ADDENDUM NO. 2

July 29, 2026

The Solanco Area School District | New District Administration Offices & Turf Fields
CRA Project No. 3706

A6.4

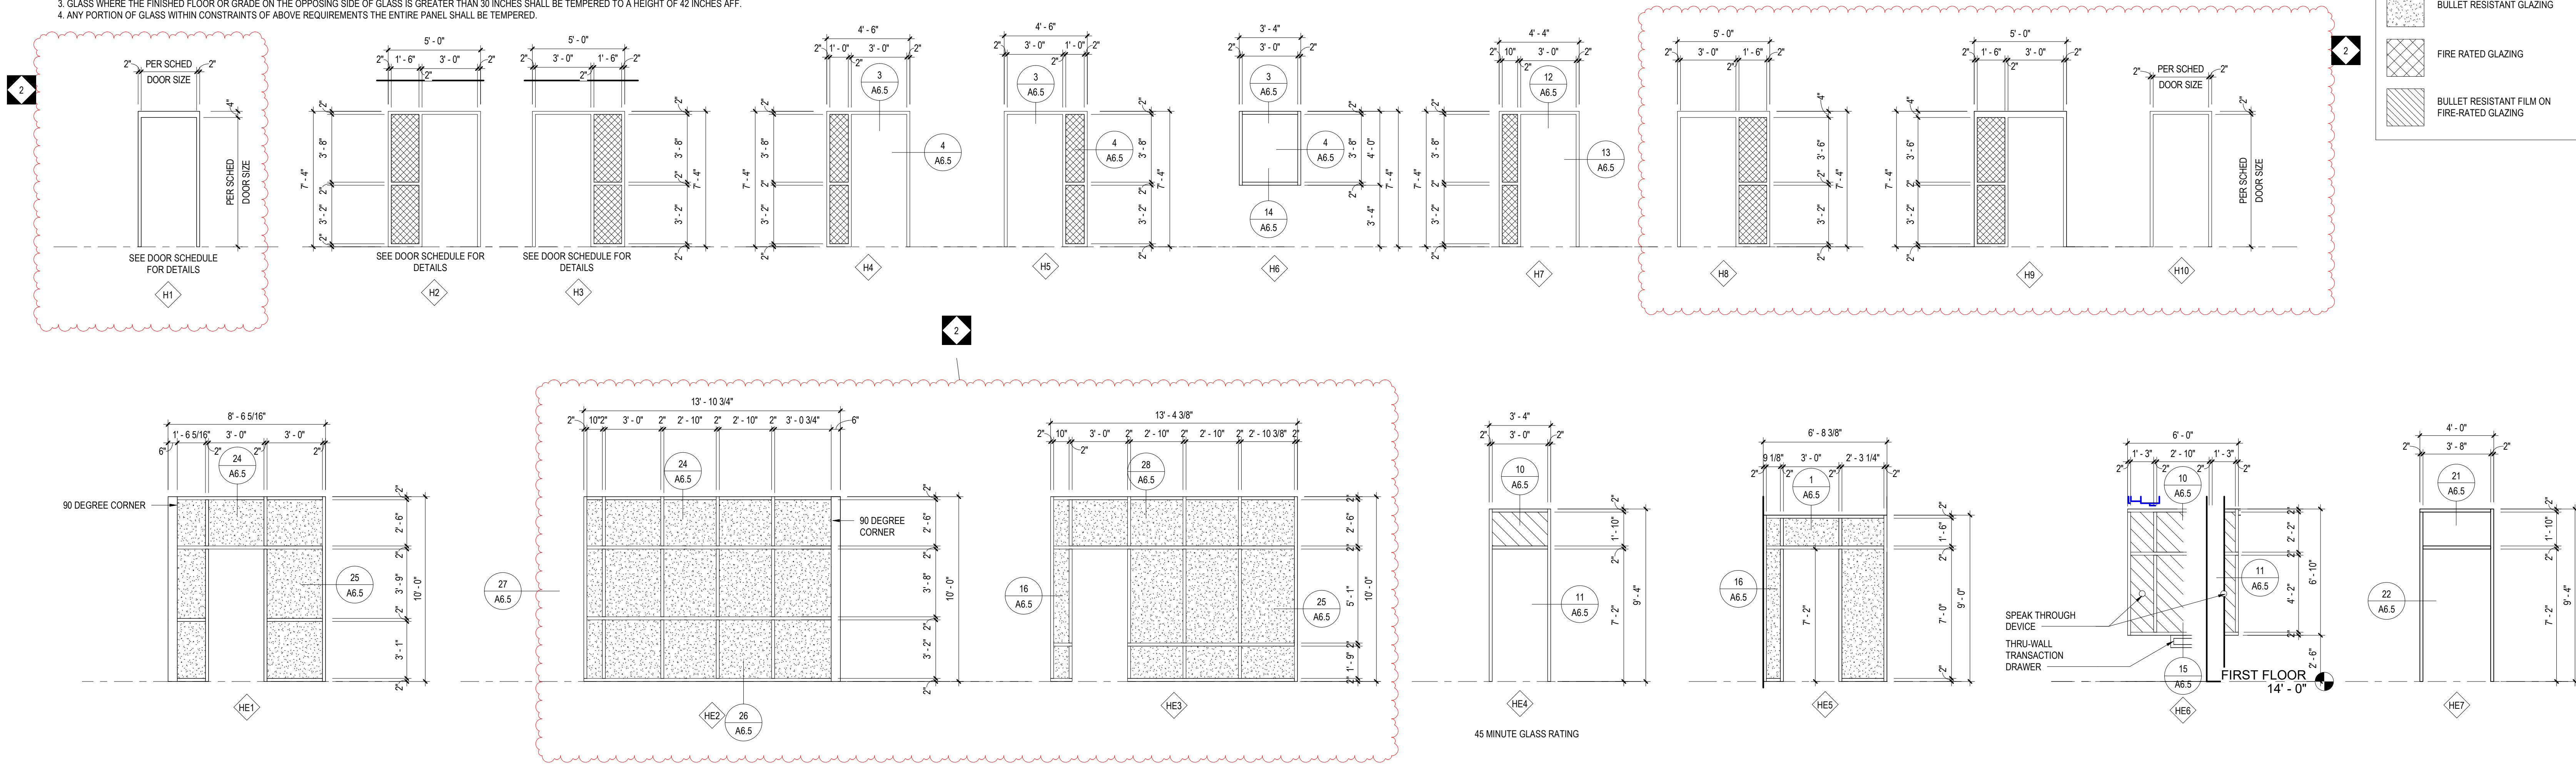
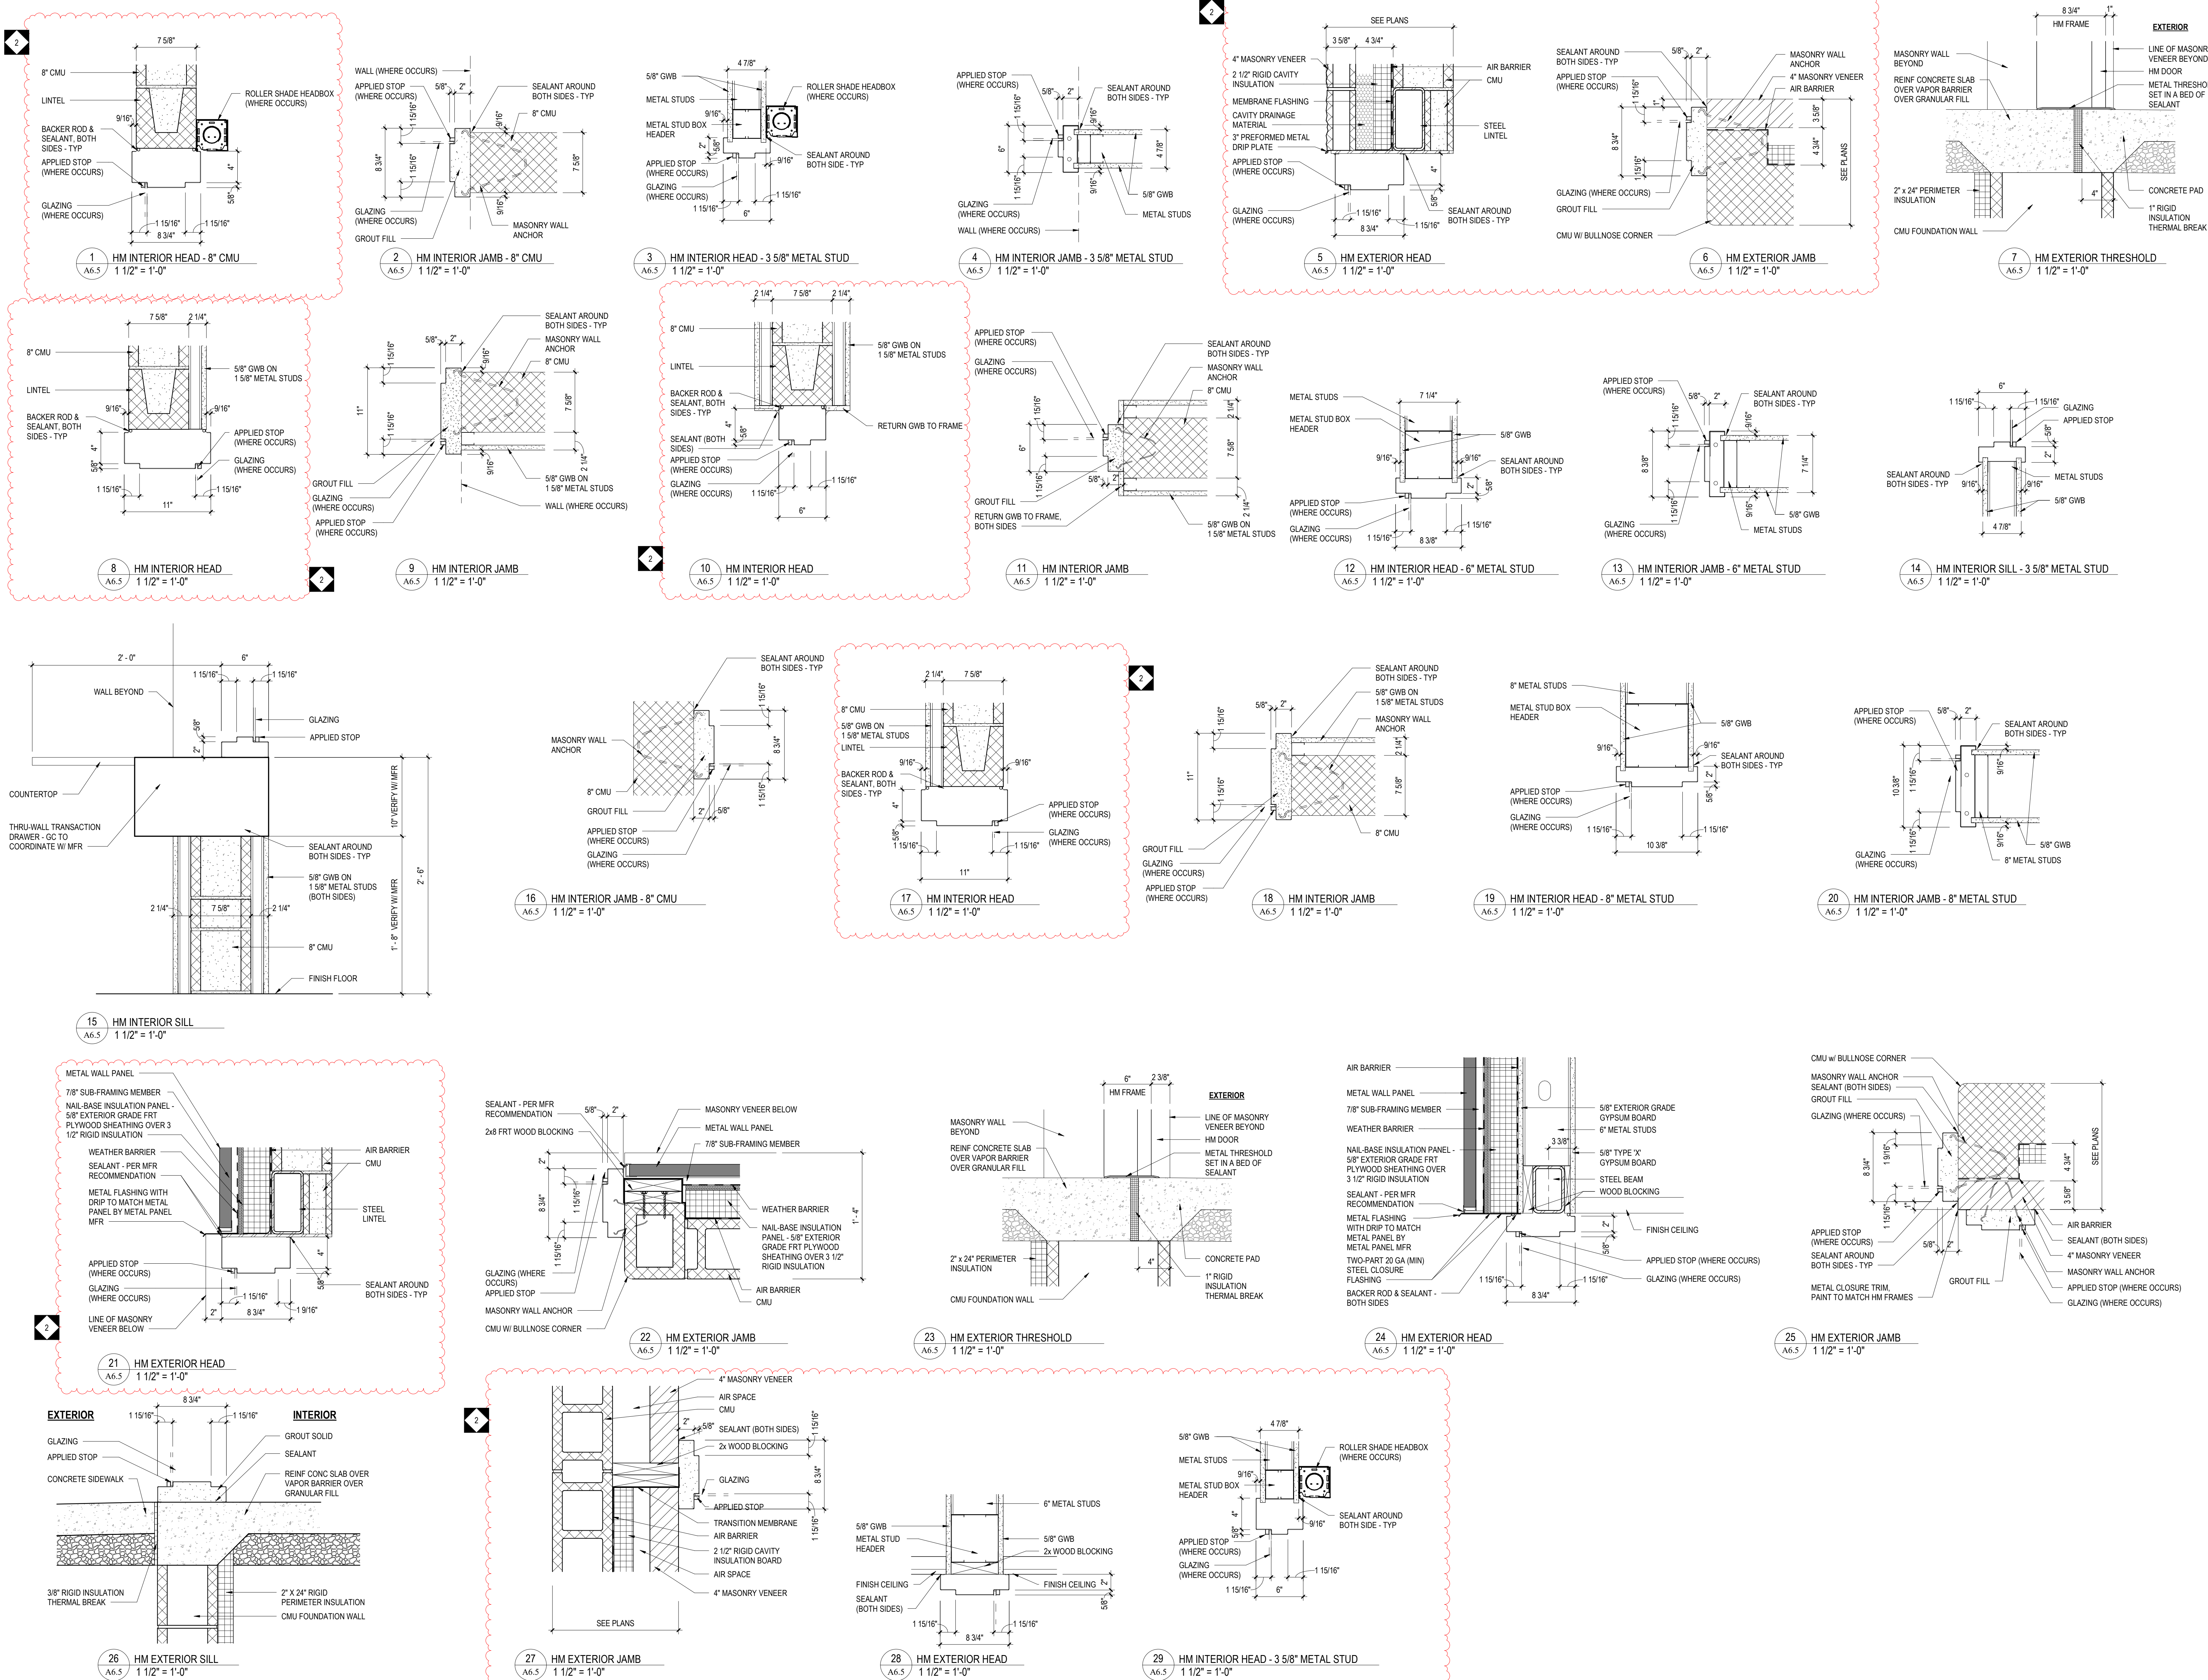
DRAWING A6.4 – HOLLOW METAL FRAME ELEVATIONS

1. **REVISE** Frame Elevation 'H1' to include a 4" head in lieu of 2".
2. **ADD** Frame Elevations H8, H9 and H10, see revised sheet attached.
3. **REVISE** Frame Elevations 'HE2' and 'HE3.'

A6.5

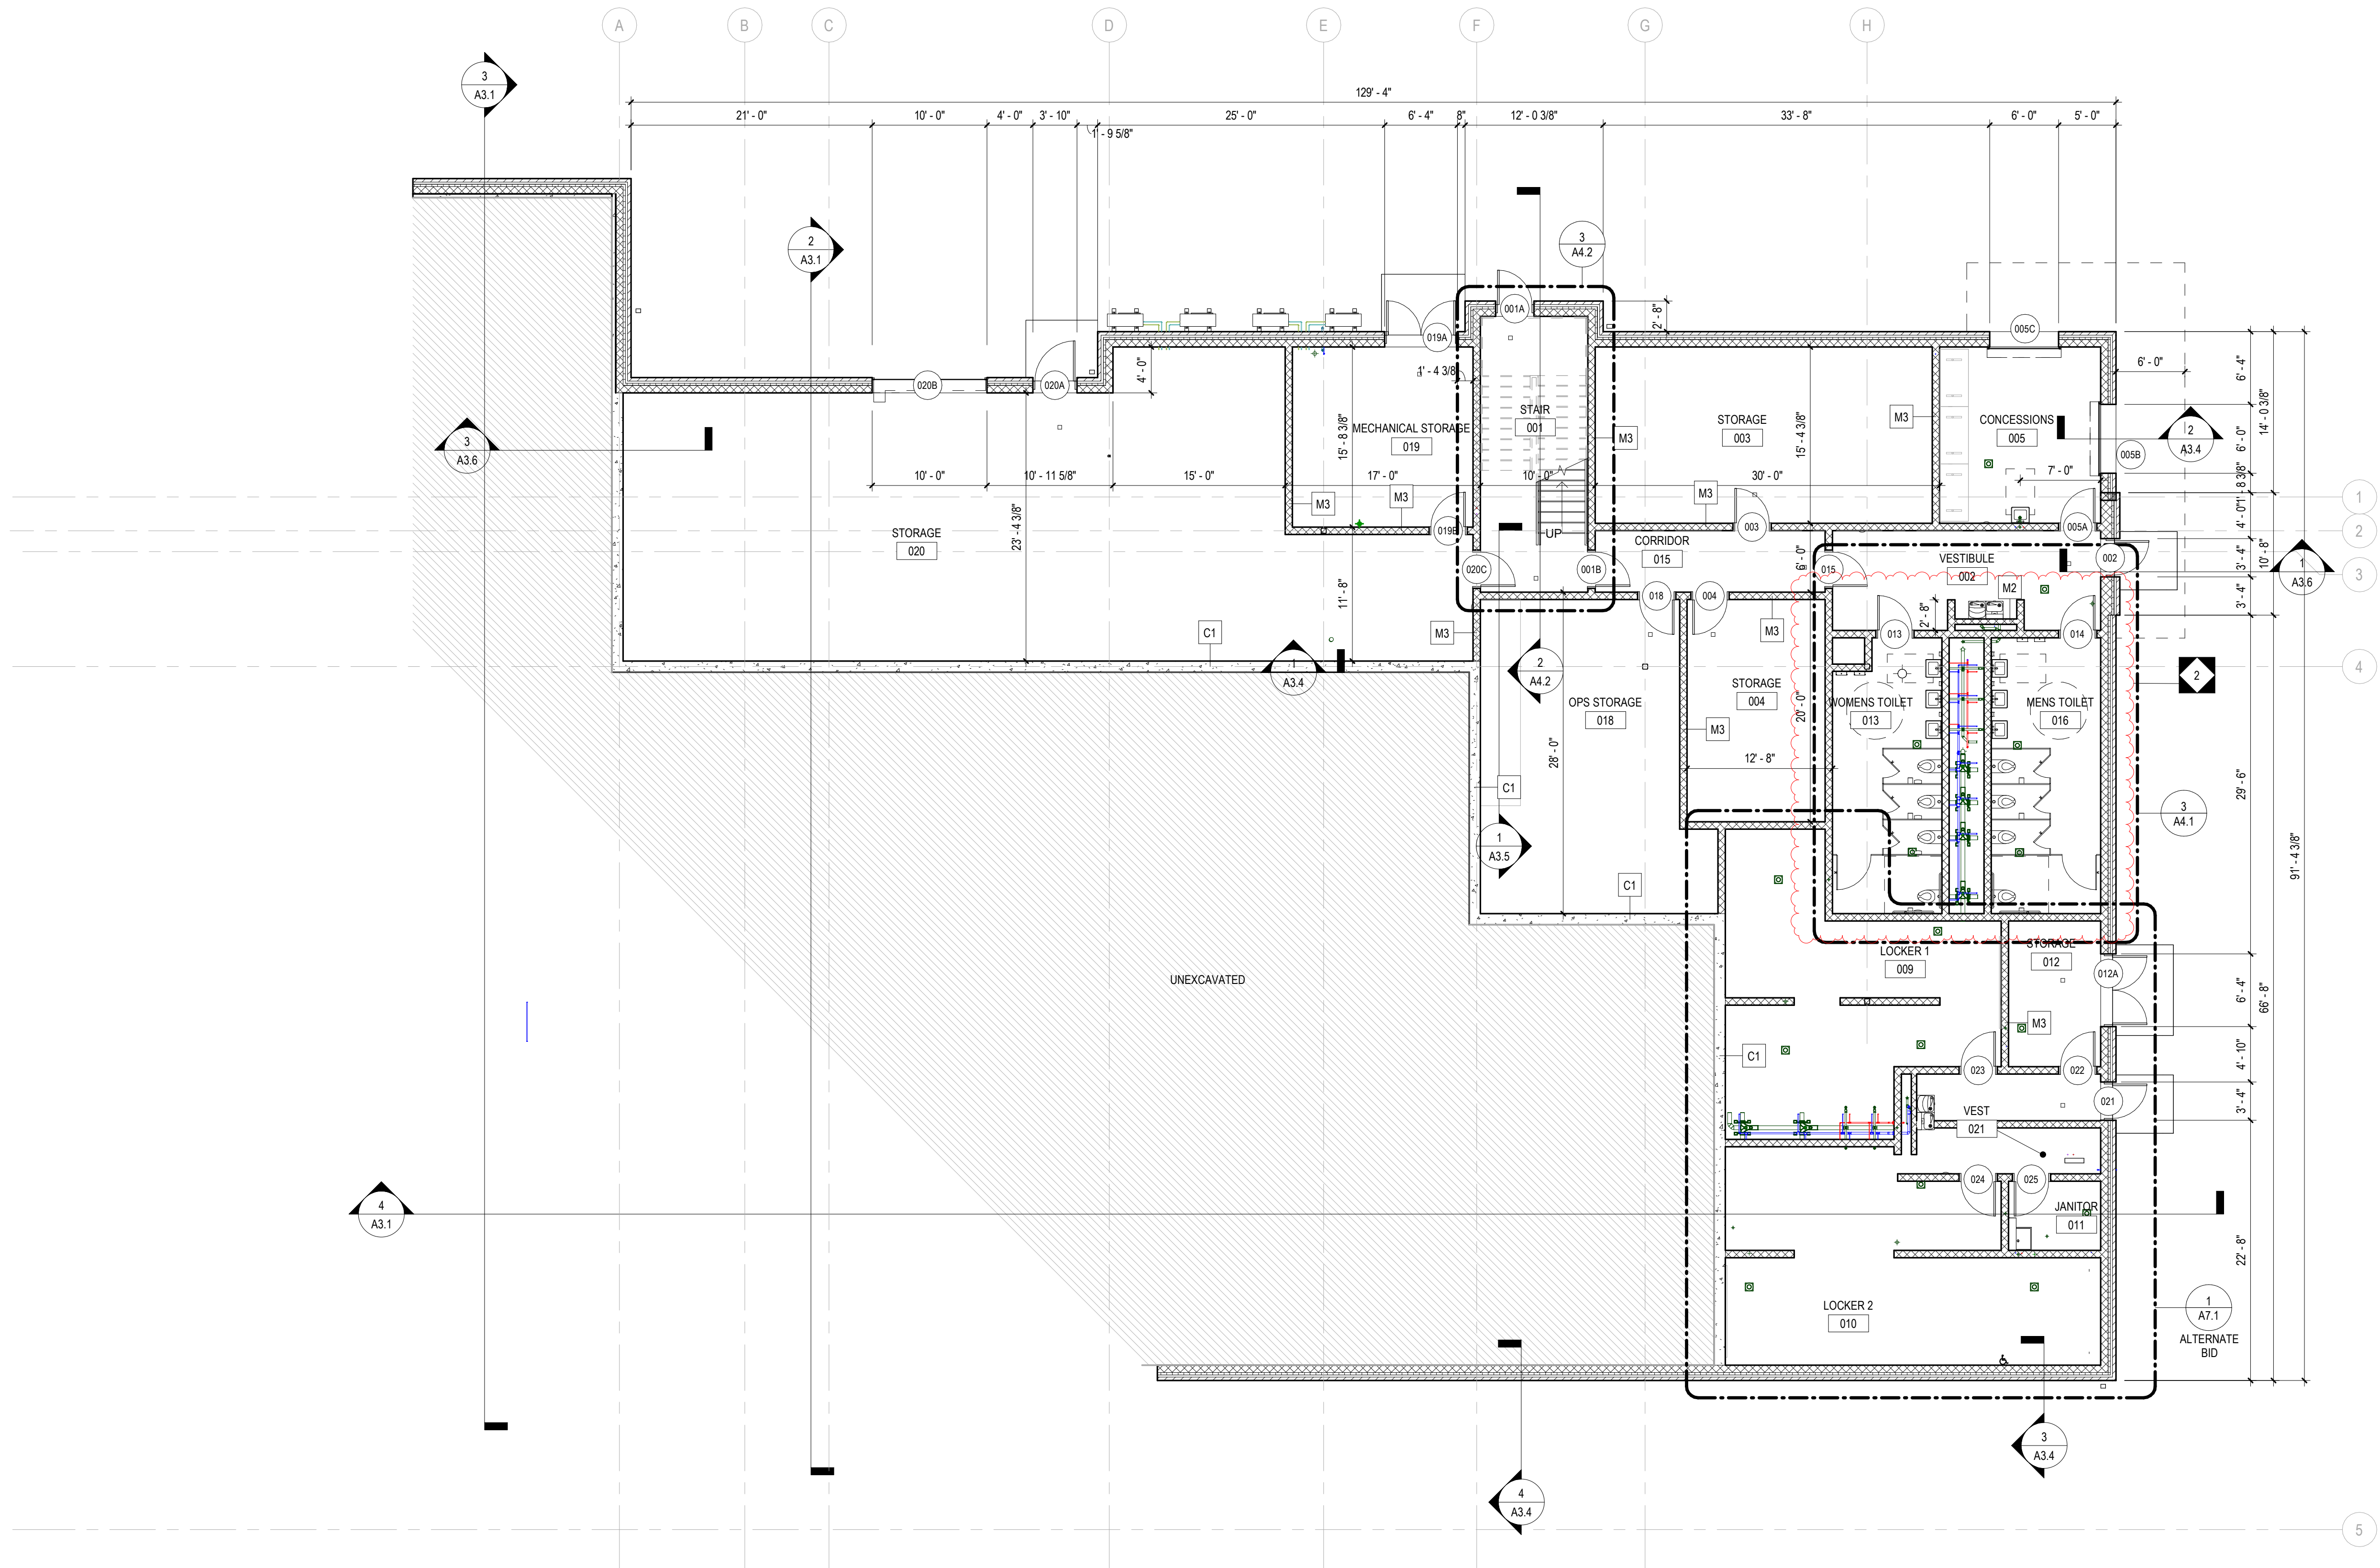
DRAWING A6.5 – HOLLOW METAL FRAME DETAILS

1. **REVISE** Details 1, 5, 8, 10, 17, & 21 to be a 4" head in lieu of 2", see revised sheet attached.
2. **REVISE** rabbet dimensions on Details 5 and 6 to be equally 1 15/16", see revised sheet attached.
3. **ADD** Frame Dimensions to Details 27 & 28.
4. **ADD** Detail 29 including 3 5/8" Metal Stud with 4" Head, see revised sheet attached.
